November 24, 2021

Subject: George Hall Elementary School HVAC Replacement
San Mateo - Foster City School District
Aedis Project No. 2021005.02
DSA Application #01-119523

ADDENDUM NO. 1

E3.1

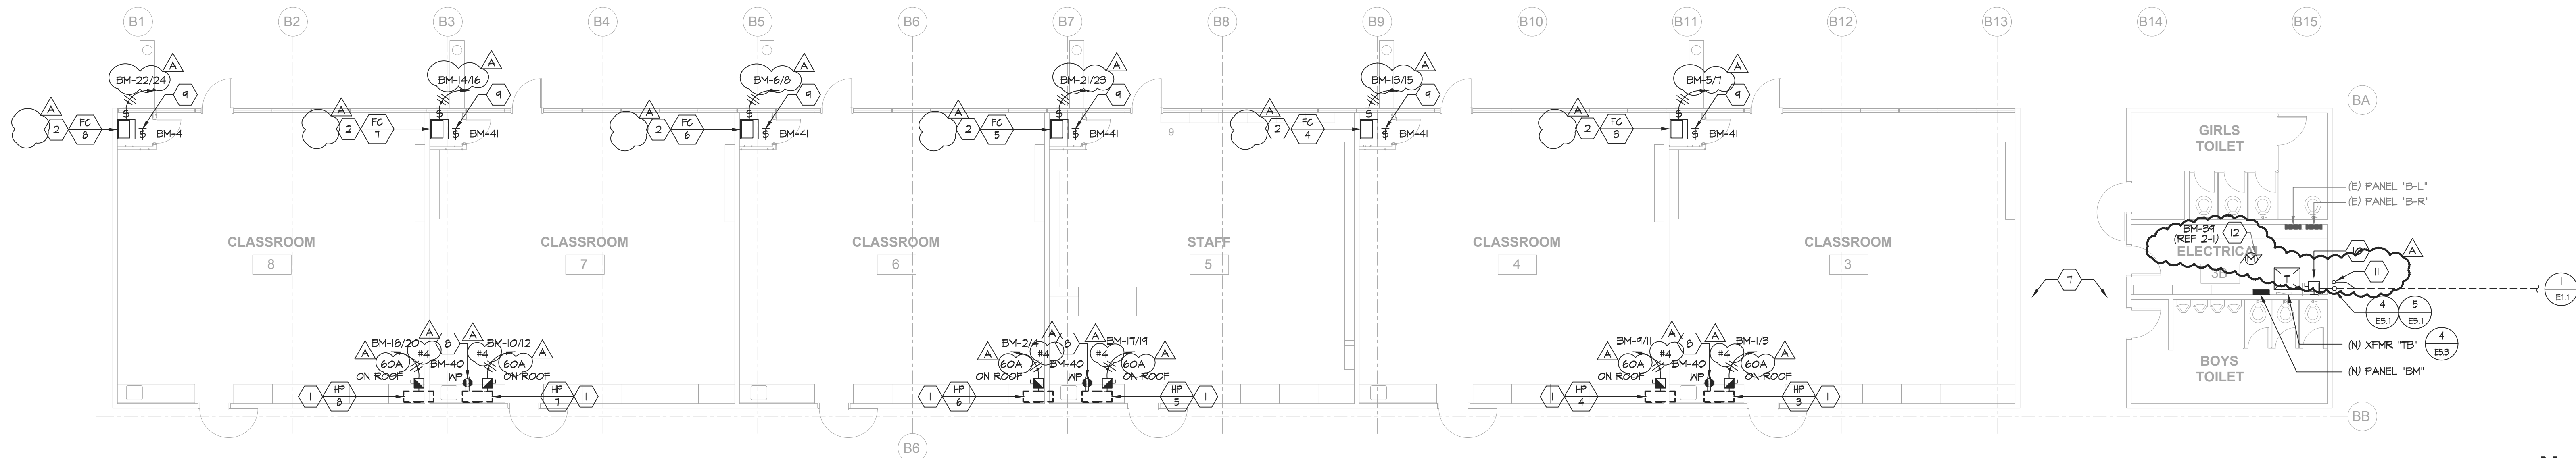
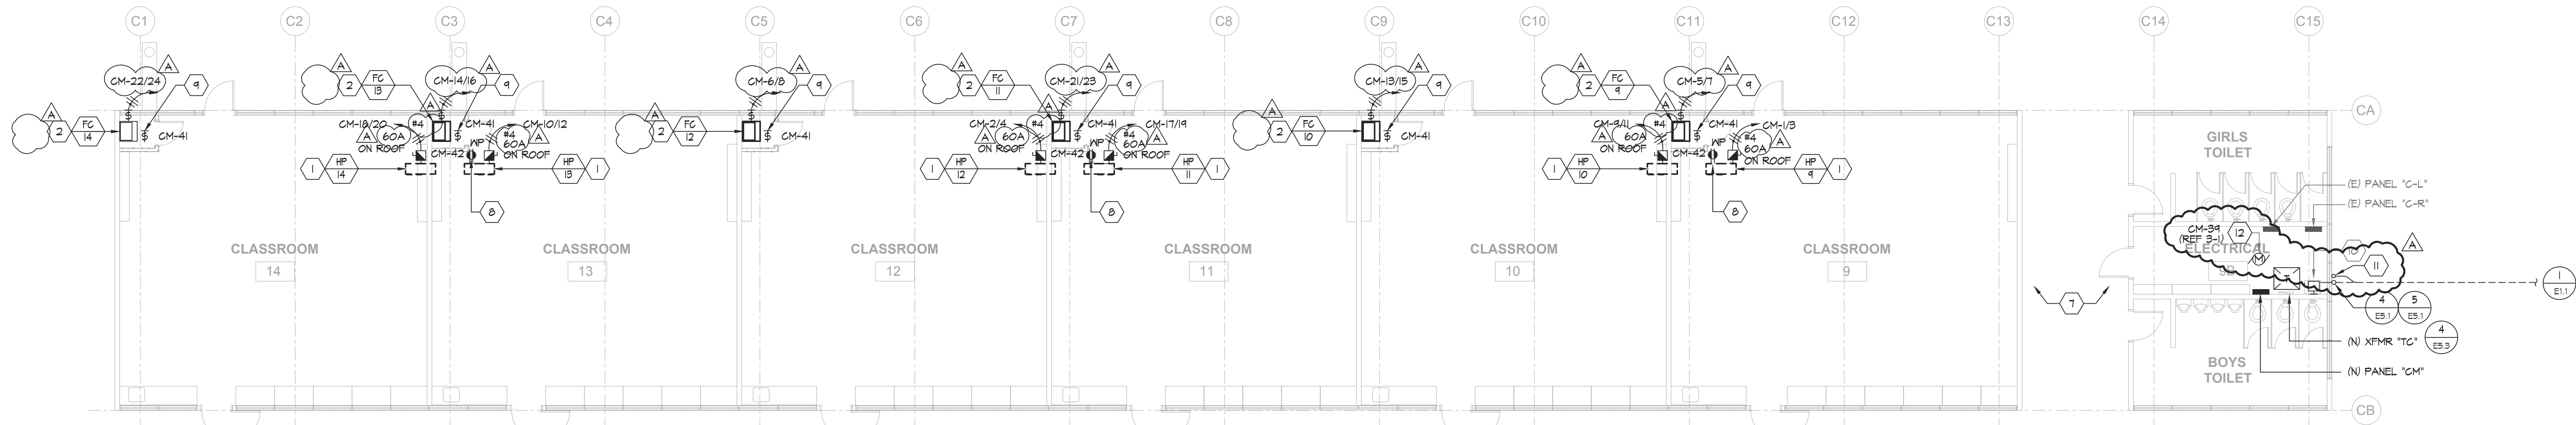
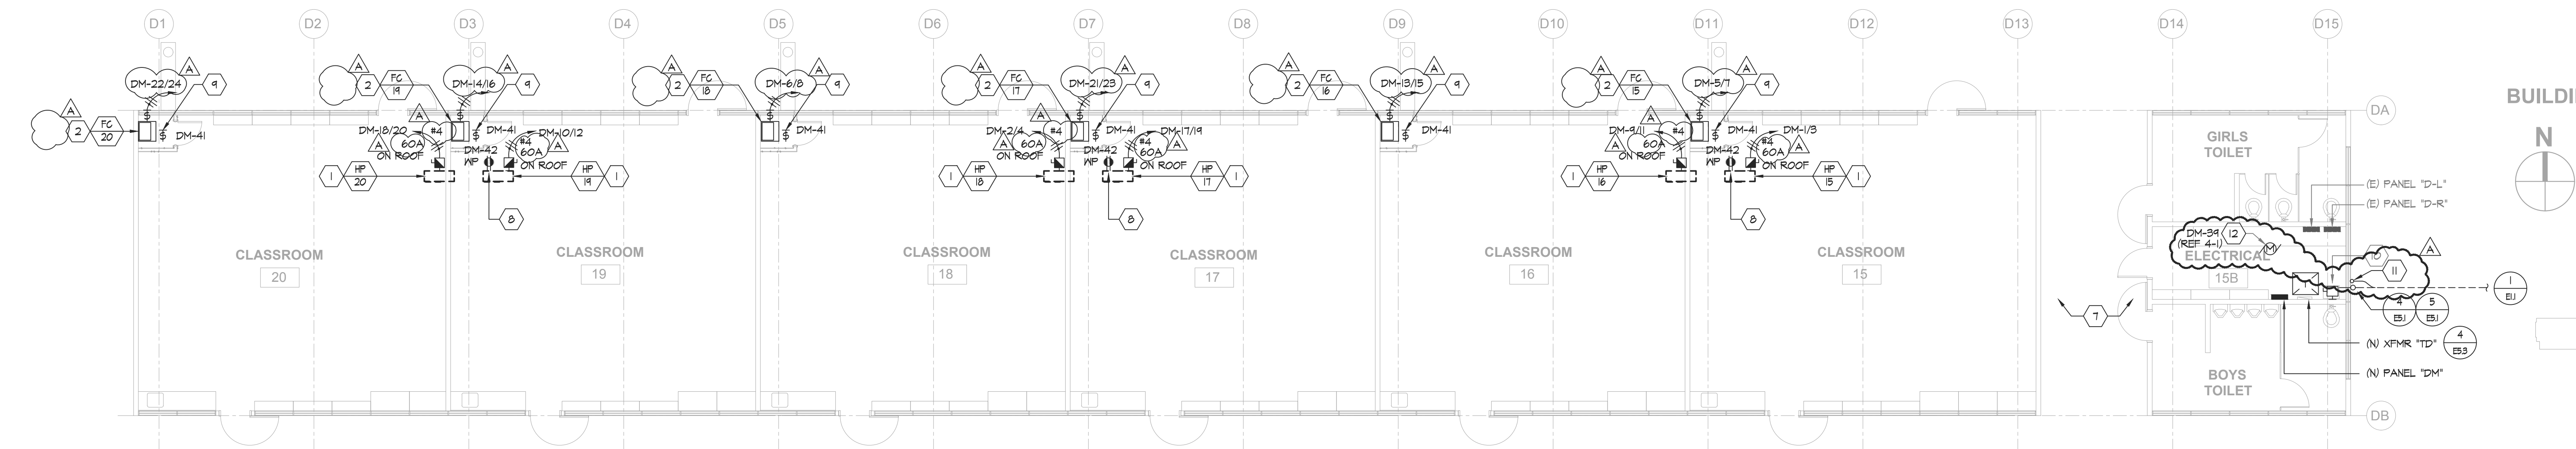
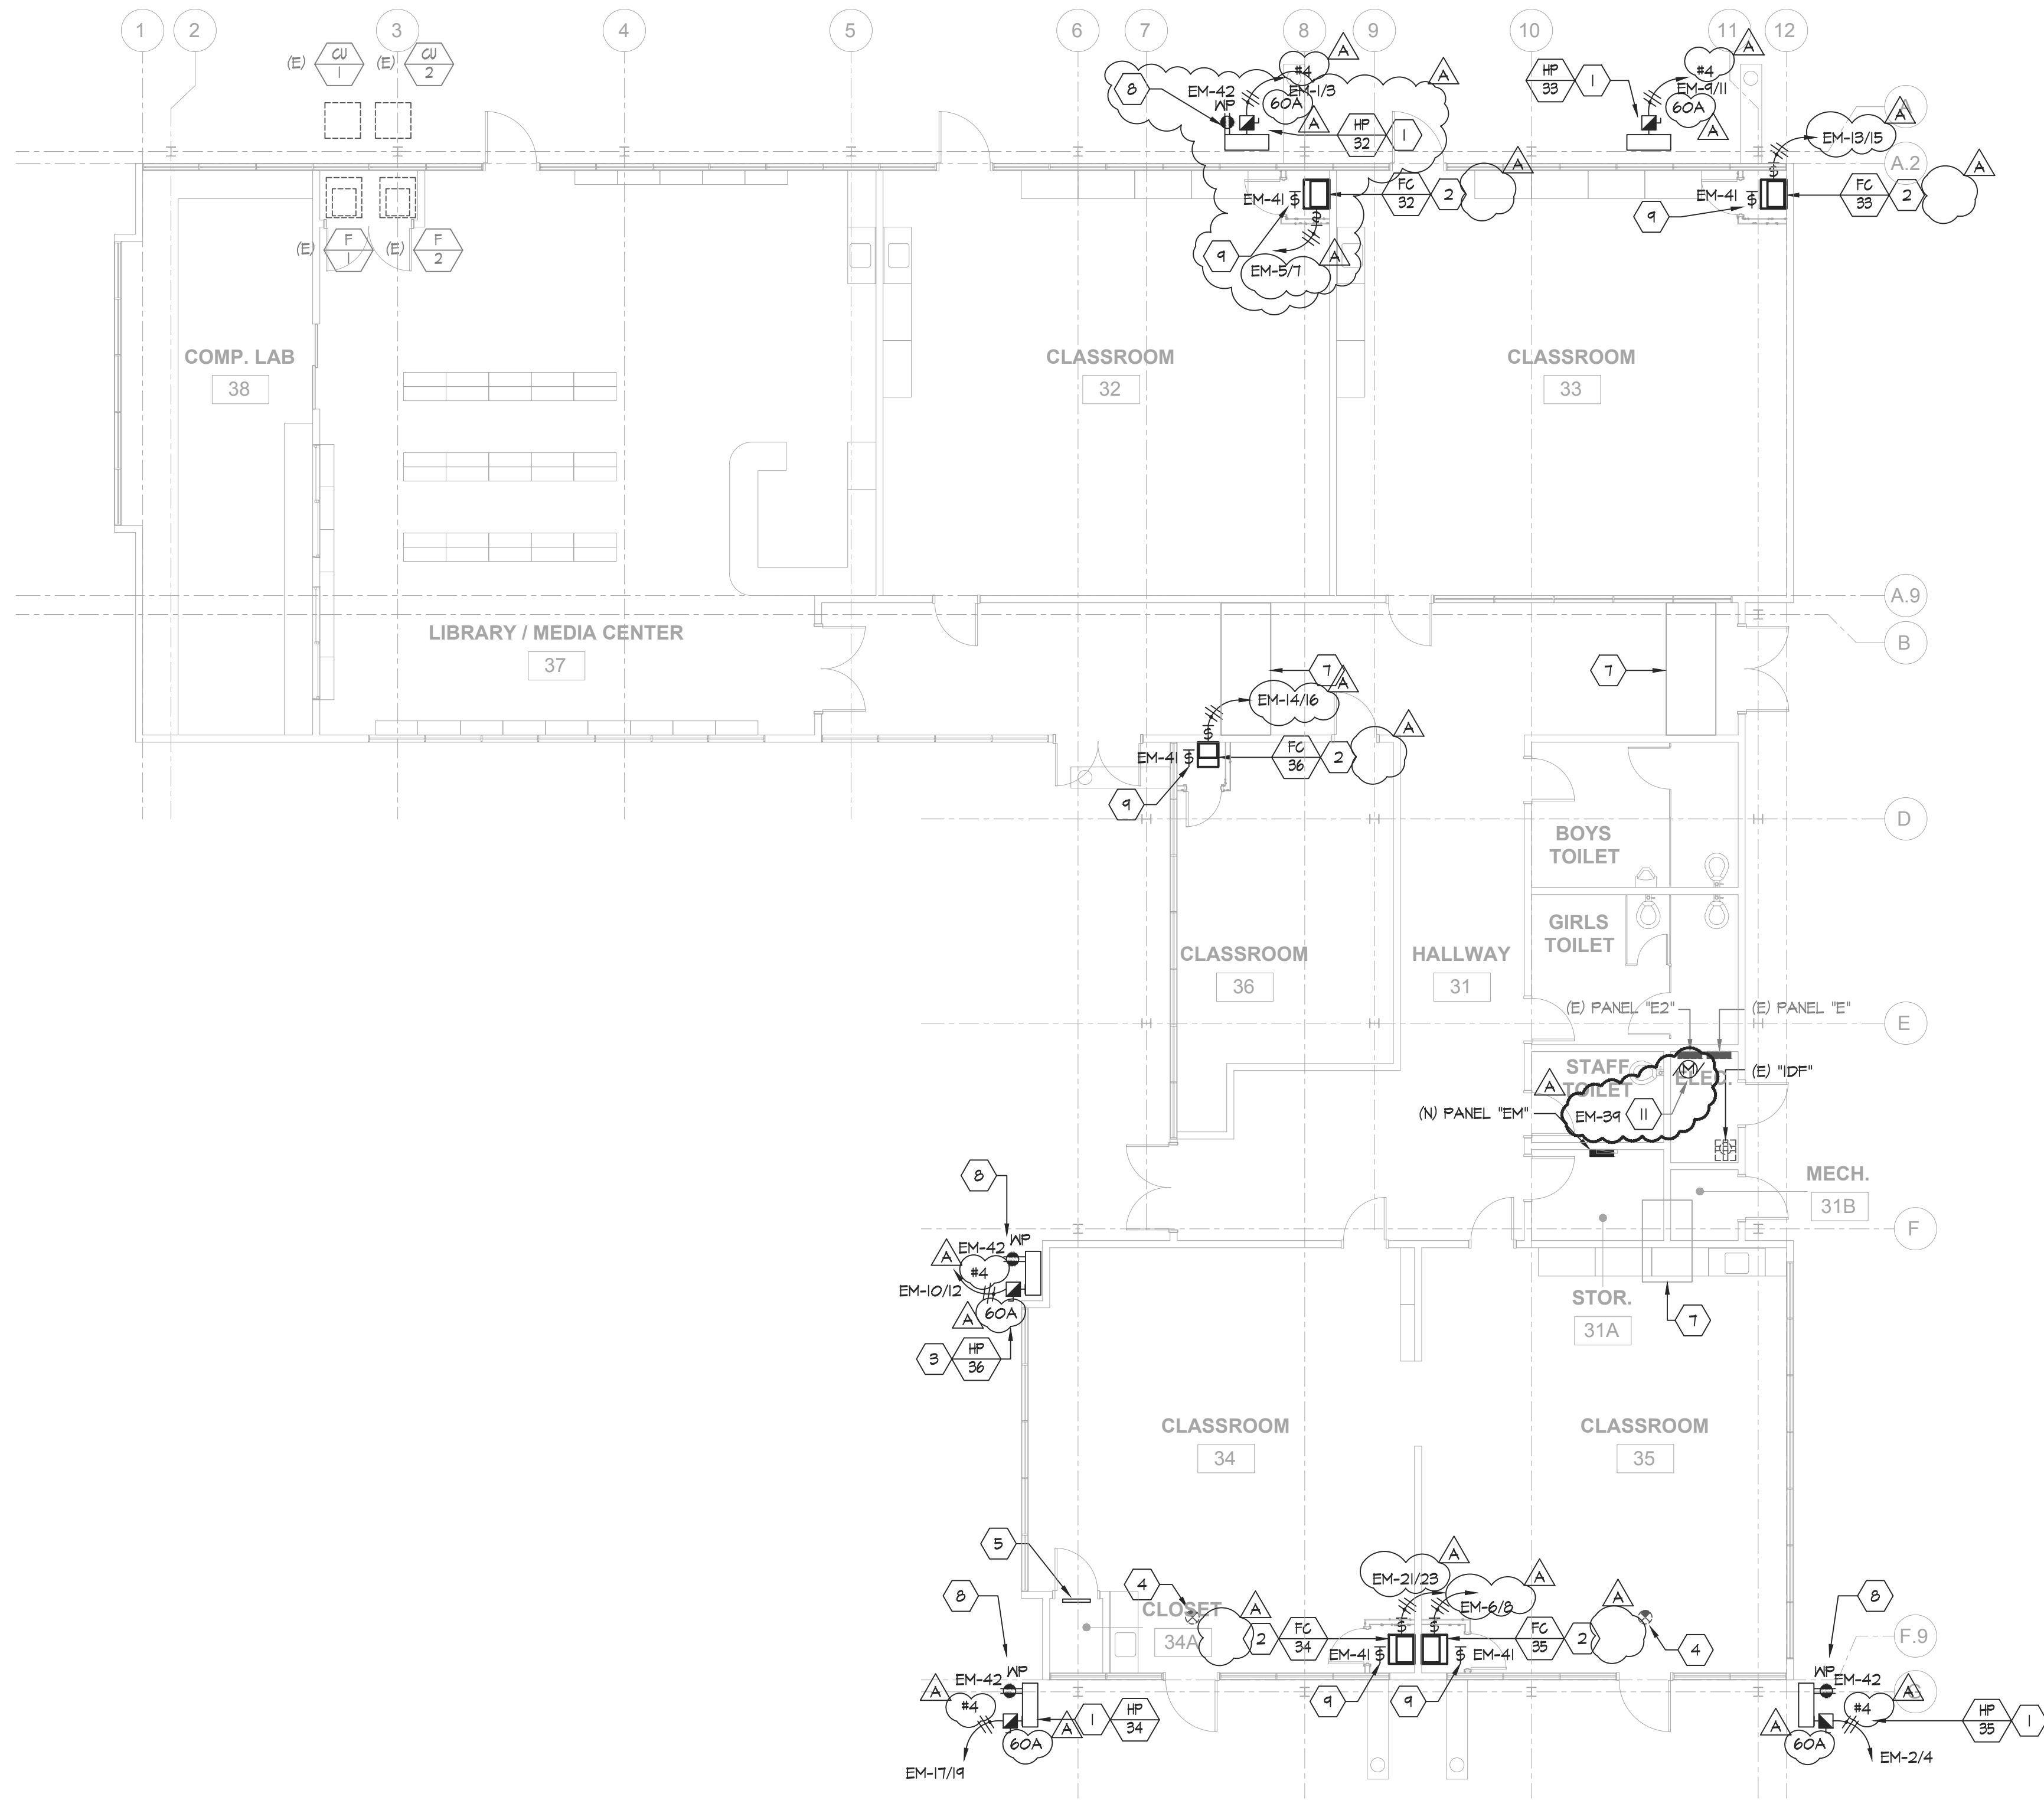
Revise: Electrical plans 1/E3.1, 2/E3.1, 3/E3.1 & 4/E3.1 per AD1-E3.1

Add: General Note #6 per AD1-E3.1

Revise: Sheet Note #6 per AD1-E3.1

Add: Sheet Notes #11 & #12 per AD1-E3.1

Add: Solar Conduit stub ups at each wing per AD1-E3.1

Add: Power for exhaust fan per AD1-E3.1

1 ELECTRICAL NEW FLOOR PLAN - ESCALON BLDG.
E3.2 SCALE: 1/8" = 1'-0"

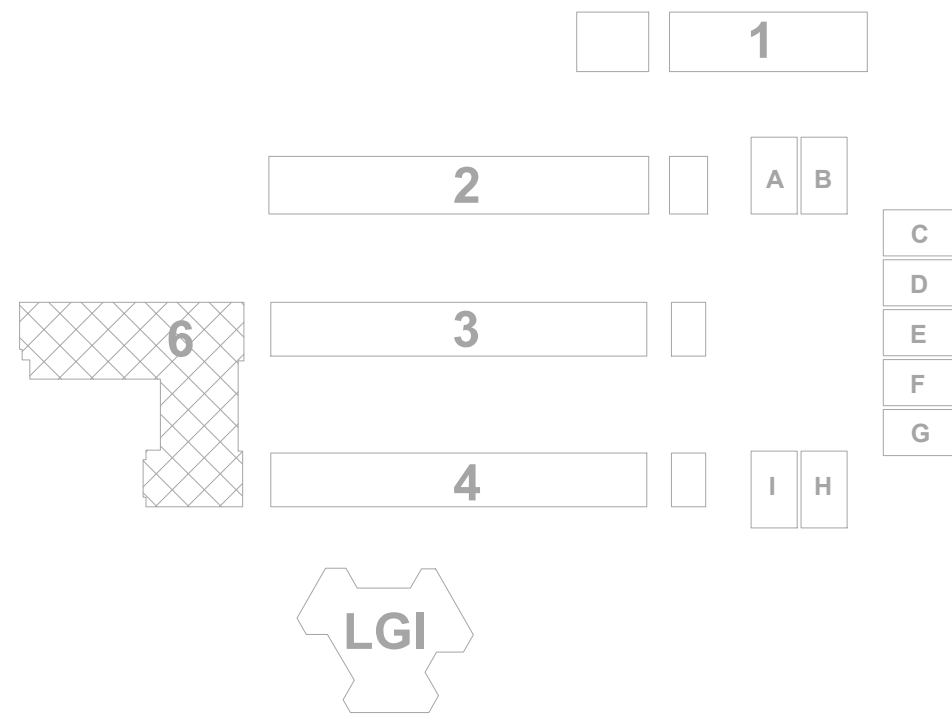
Revise: Electrical plan 1/E3.2 per AD1-E3.2

Add: Power for exhaust fan at building per AD1-E3.2

Add: General Note #6 per AD1-E3.2

Revise: Sheet Note #5 per AD1-E3.2

Omit: Sheet Note #10 per AD1-E3.2

Add: Sheet Note 11 per AD1-E3.2

Revise: Location of HP-2 per AD1-E3.2
